Response to Request for Information (DA22/14809) Digital Advertising Sign – Parramatta Road, Granville

This letter has been prepared by *Keylan Consulting Pty Ltd* (Keylan) on behalf of Sydney Trains (the Applicant) to address the Department of Planning and Environment's (DPE) Request for Additional Information (RFI) dated 23 December 2022 in relation to Development Application (DA22/14809).

Figure 1: Aerial image demonstrating the sign location and properties on Junction Street (Source: Six Maps)

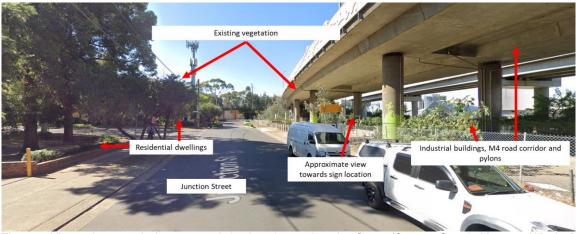
Ref.	Issues raised	Response
A	DPE	
		 would not be capable of fitting within the envelope of the bridge. It is not uncommon for the media operator logo to be located to the side of digital signs. A suite of examples of NSW sites is provided at Attachment E.
4	The closest residential properties are located 150m north-east of the site along Junction Street. Confirm whether the proposal will have any visual impact on these properties and (if relevant) any existing applications for development along the street.	The proposed sign is not anticipated to result in visual impacts on residential dwellings located along Junction Street to the northeast of the site. Views towards the sign are not likely to occur as there are existing industrial buildings located directly opposite these dwellings which screen views towards the sign. In addition, the raised structure of the M4 Western Motorway will also screen the sign when viewed from these properties (refer Attachment B below).

In addition to the above, the distance between Junction Street and the sign is 200m and there are also existing mature trees located along both sides of Junction Street. This landscaping will also screen potential views towards the sign (refer Attachment B).
		On the basis of the above, there are negligible potential visual impacts as a result of the proposed sign on the residential properties to the north-east of the site.
В	TfNSW	
1	TfNSW has reviewed the submitted documentation and provides concurrence to the proposed digital signage, subject to the approval of the Department of Planning and Environment and the requirements being included in the development consent.	Noted. The Applicant has reviewed the proposed conditions of consent provided by TfNSW and has no objections.
